PLAN REVIEW	Approved	Dis-Approved	Date
Submittal Date: 9-29-16			
City Engineer	—		
Assistant City Engineer	—		
Civil Engineer			10/14/16
Water	—		
Wastewater	—		
Streets	—		
Engineering	BWH		9/30/16
Fire Department	—		
Planning & Zoning	—		
Other	—

Minor Comments
As-Noted

WANDA RIDGE ESTATES PHASE 2

SUBMITTAL #3
SEP 29 2016
City of Rockwall Engineering Dept.

DRIVEWAY CULVERT CALCULATIONS

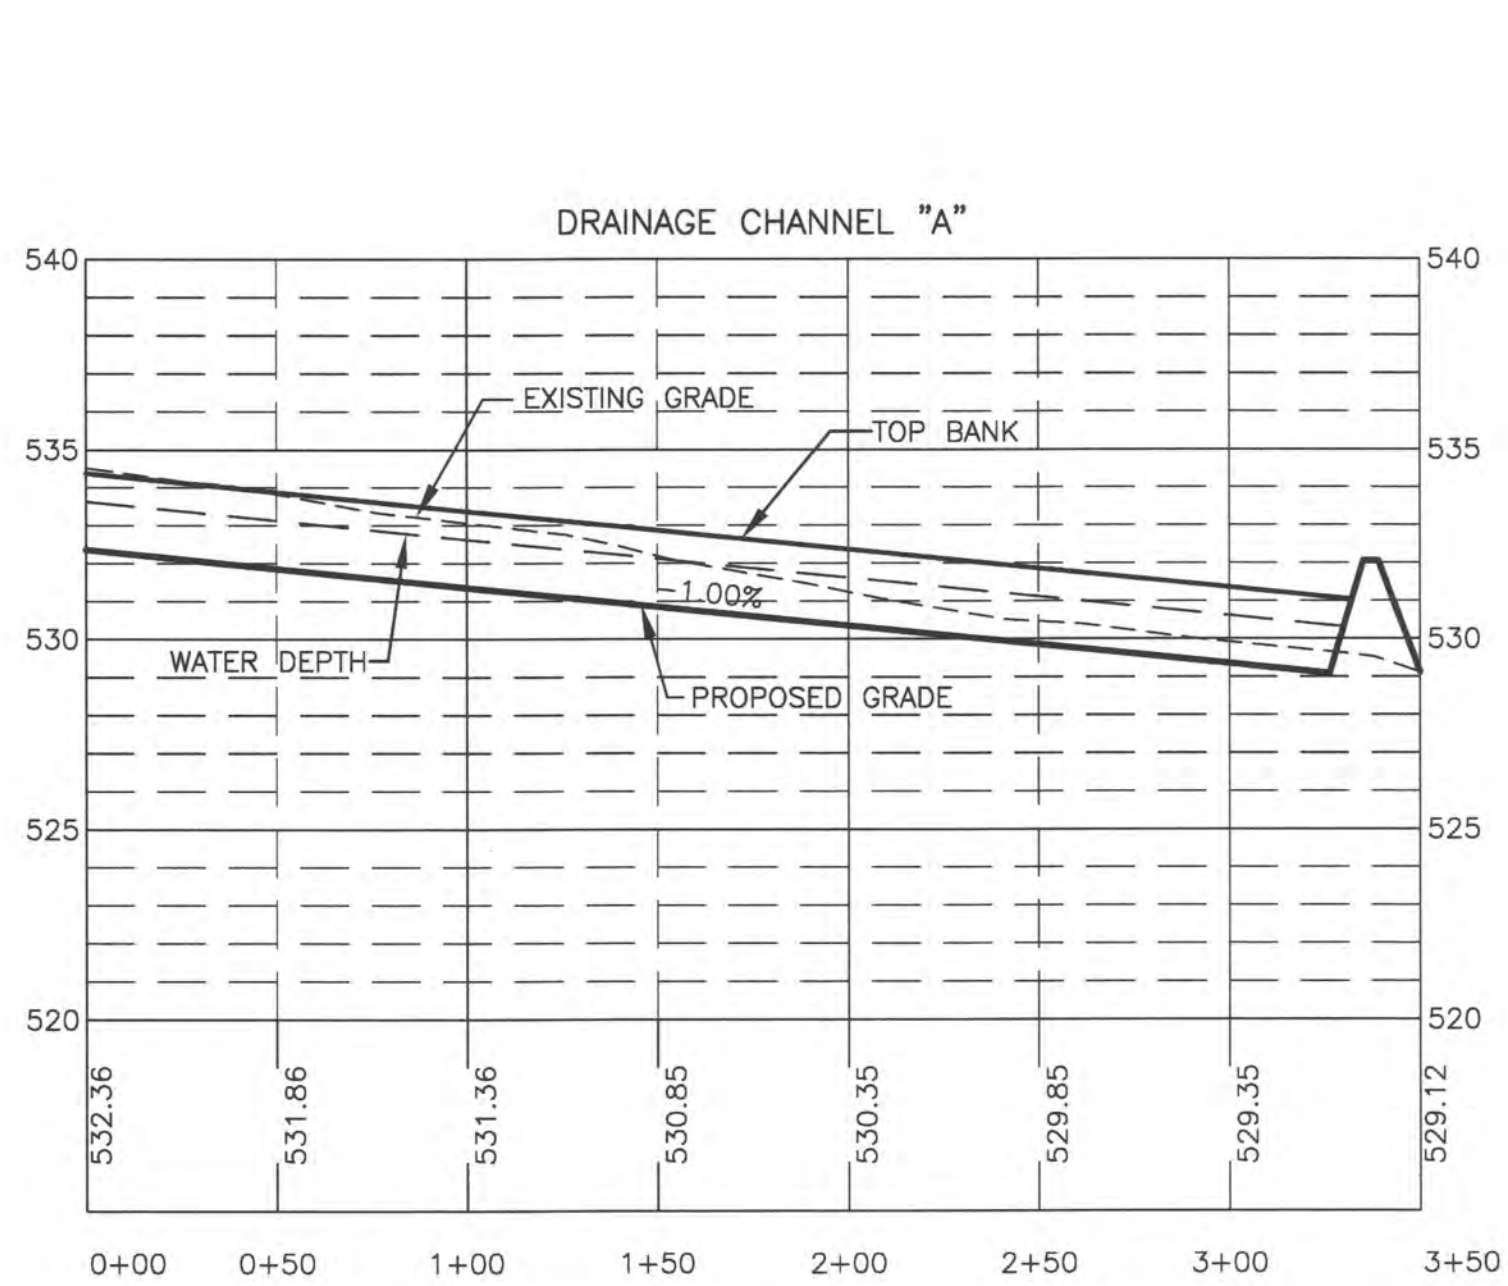
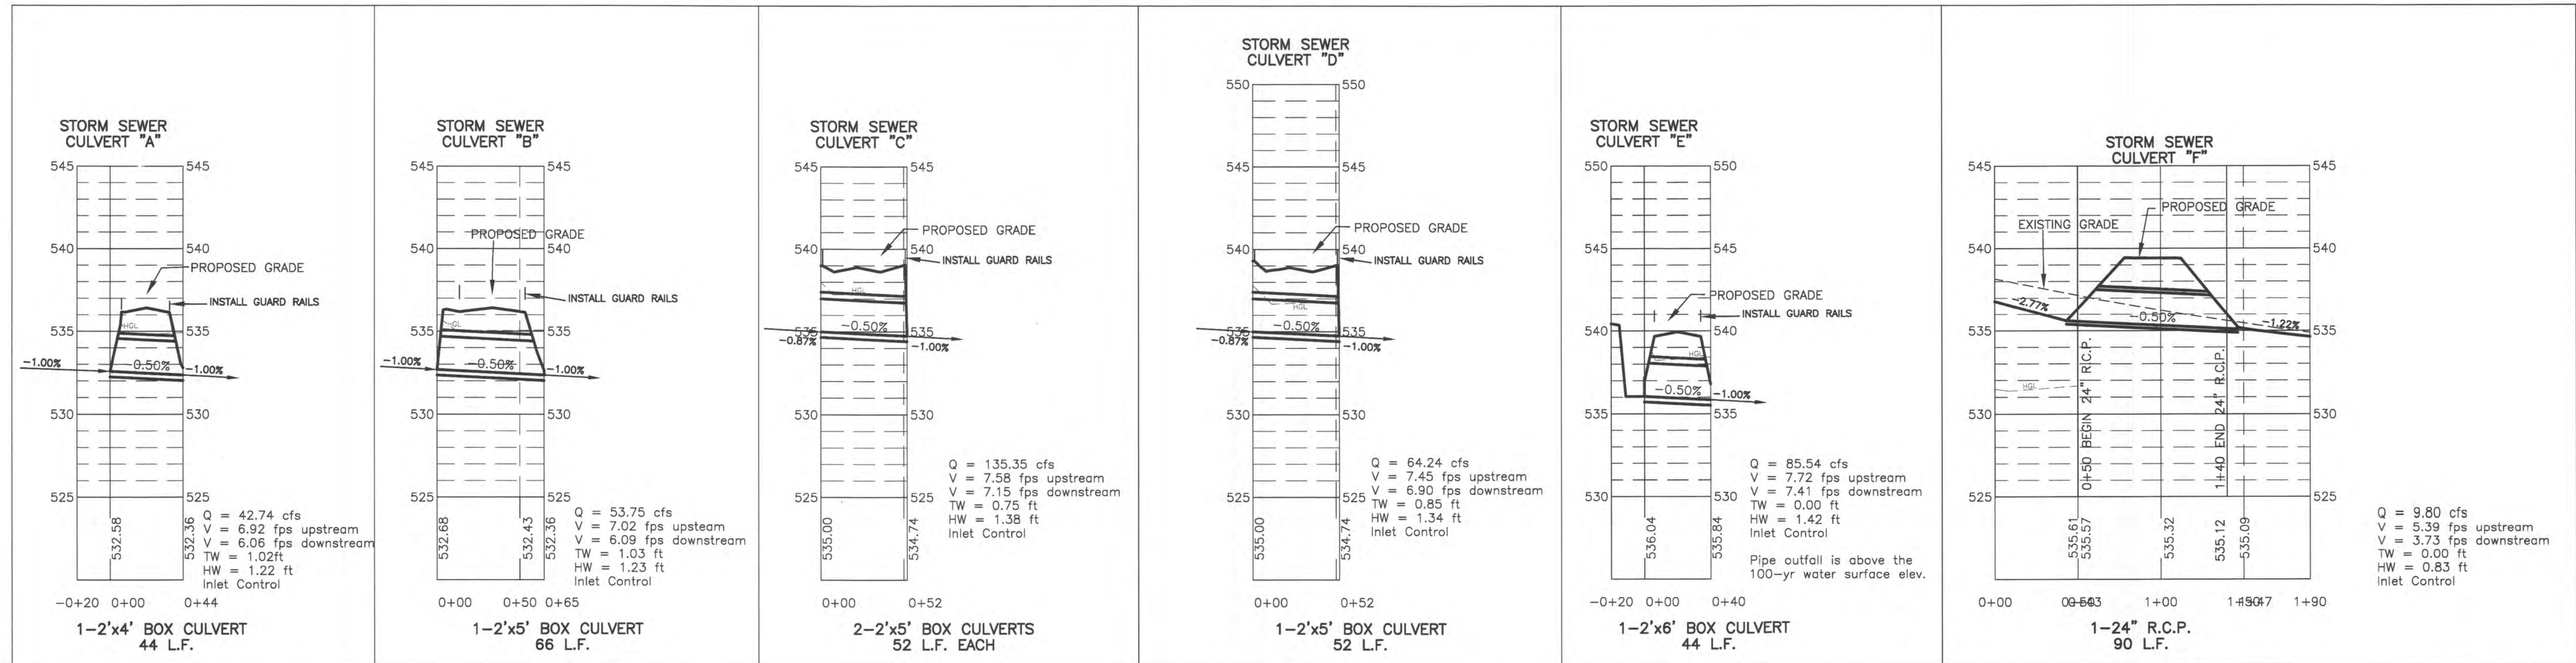
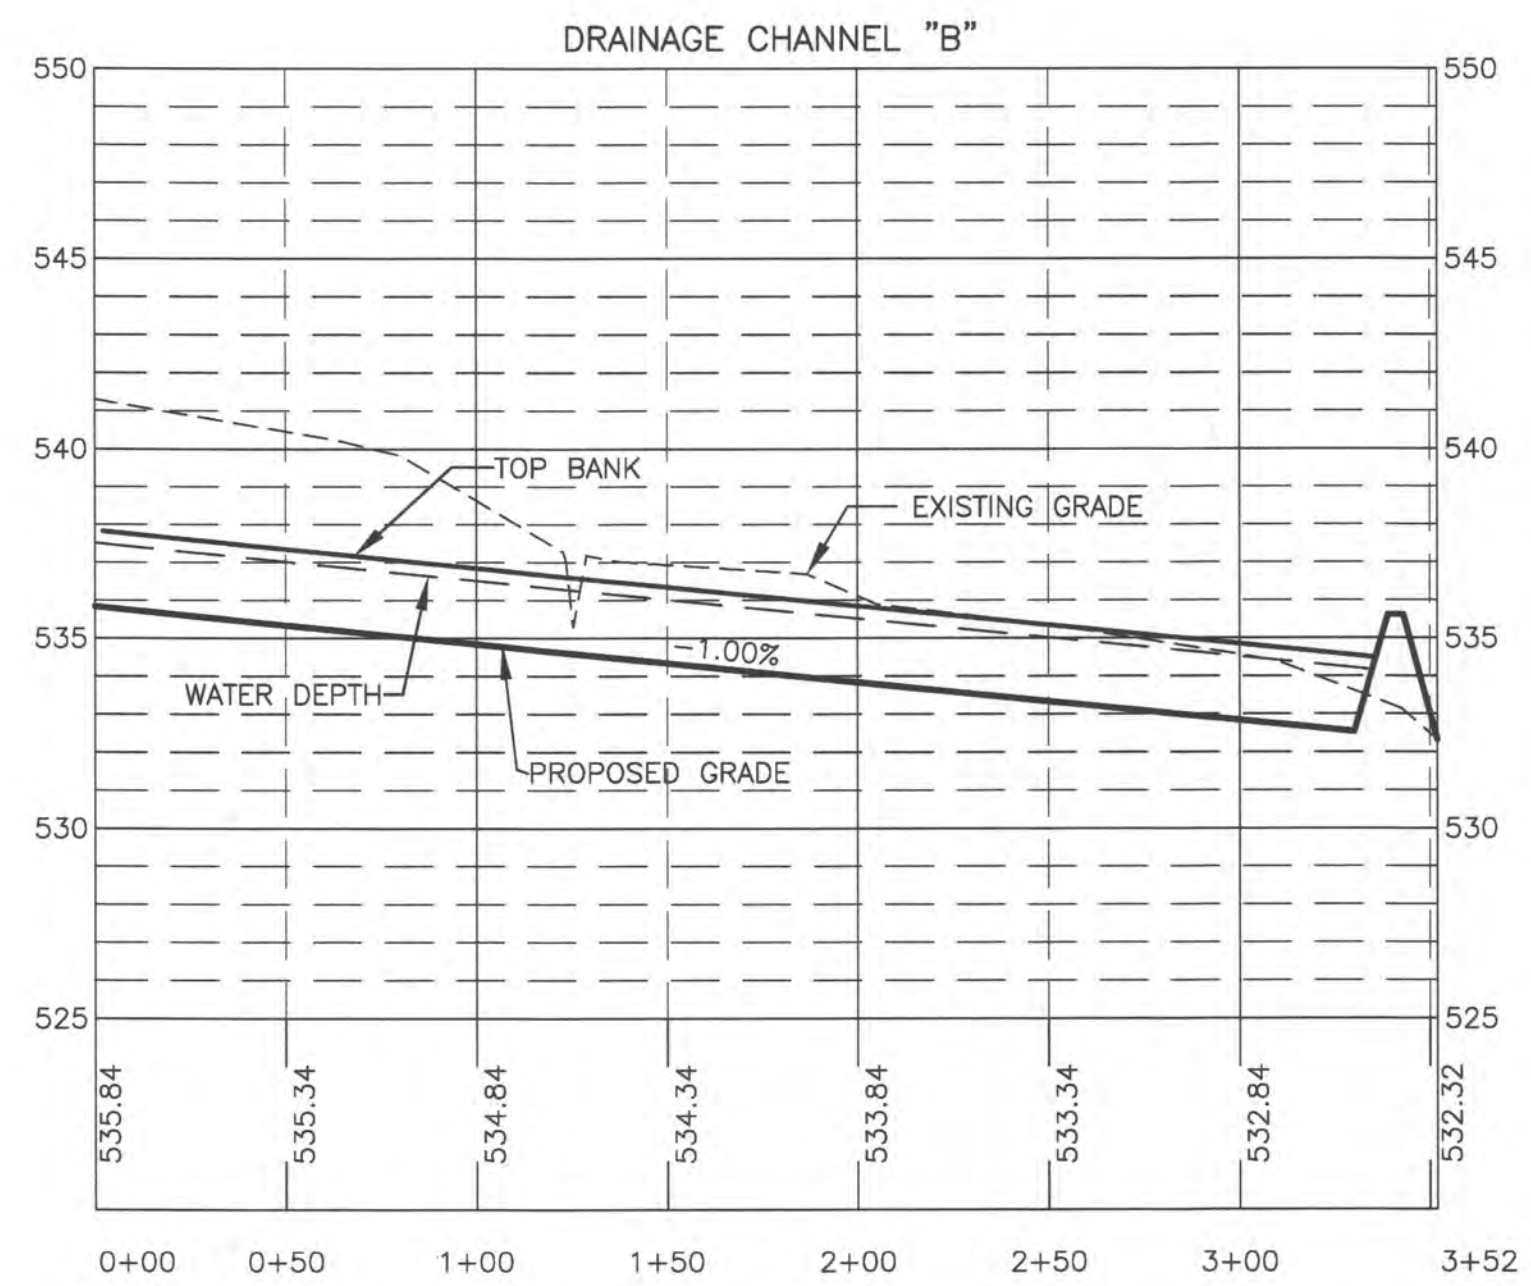
Q = 121.71 cfs
V = 7.53 fps
Water Depth = 1.67 ft
100-yr Water Depth = 1.92 ft
Recal for 6' min bottom width
